**PLANNING DIRECTOR'S VARIANCE**  
1231 "I" STREET, SUITE 200, SACRAMENTO, CA 95814

- APPLICATION:**
- A. Negative Declaration
  - B. Planning Director's Variance to reduce the required side yard setback from five feet to three feet on 0.11 ± vacant acres in the Standard Single Family (R-1) zone.
  - C. Planning Director's Variance to allow a masonry wall to exceed the six foot height requirement by two feet.

**LOCATION:** 1832 51st Street

**APPLC. NO. P90-472**

NORTH ELEVATION  
SCALE 1/4" = 1'-0"

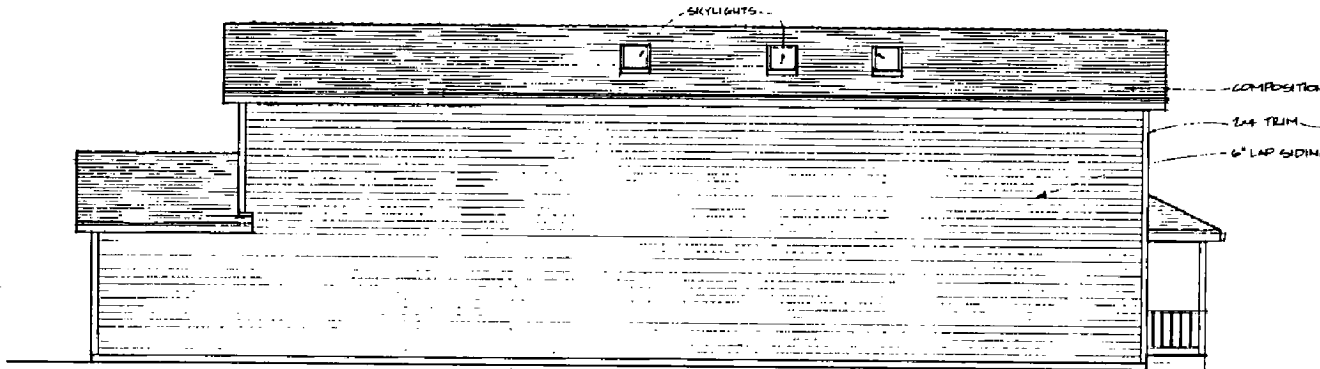
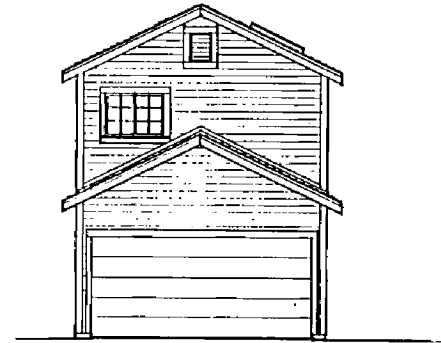
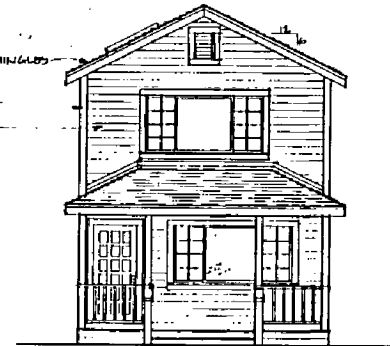
The proposed elevations show horizontal lap siding with a composition shingle roof. Staff recommends a 2x12 wood band painted in the trim color be added to the north and south elevation to align with the first story roof. Staff also recommends the roof be constructed with 25 year laminated dimensional composition shingles and the garage door be a metal sectional door.

- 1. The applicant shall add a 2x12 wood band painted in the trim color to the north and south elevation to align with the first story roof. The roof shall be constructed with 25 year laminated dimensional composition shingles and the garage door shall be a metal sectional door. The elevations shall be revised and submitted to Planning Staff for review and approval prior to the issuance of building permits.
- 2. The size, style, and location of the house on the site shall conform to the plans submitted.
- 3. The applicant shall obtain all necessary building permits prior to commencing construction.
- 4. The applicant shall comply with the mitigation measures of the Negative Declaration.
- 5. The applicant shall comply with all applicable ordinances pertaining to hours of operation for on-going construction. All equipment and debris shall remain on the subject parcel.

SITE PLAN  
SCALE 1" = 1'-0"

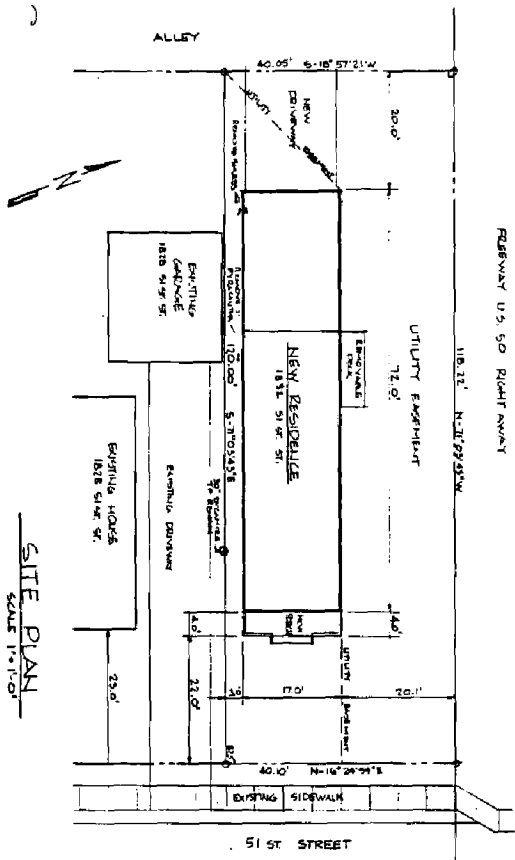
Staff has no objections to the applicant's request. The parcel is a very narrow substandard lot adjacent to Highway 50 with a 20 foot utility easement along the north property line. Previously, there was a single family residence on the site that was demolished when Highway 50 was constructed. The applicant proposes to construct a two story single family dwelling on the subject site (see Exhibits B and C). The proposed design for the house is similar to the adjacent residential properties. Allowing the south sideyard setback to be reduced to three feet will permit a house to be built that is seventeen feet wide. There is adequate space between the proposed project and the existing adjacent house. The new structure will be 17.5 feet from the existing house and three feet between garages. Staff supports this reduction because the lot is substandard in width.

The applicant is required by the Negative Declaration to construct an eight foot solid masonry wall along the north property line to mitigate noise associated with Highway 50. The applicant has agreed to construct the wall. According to the Zoning Ordinance a wall over six feet high requires a variance. Staff supports the variance for the wall height in order that the surrounding highway noise may be reduced for the proposed residence. The wall will not affect any adjacent property nor obstruct any adjacent property.
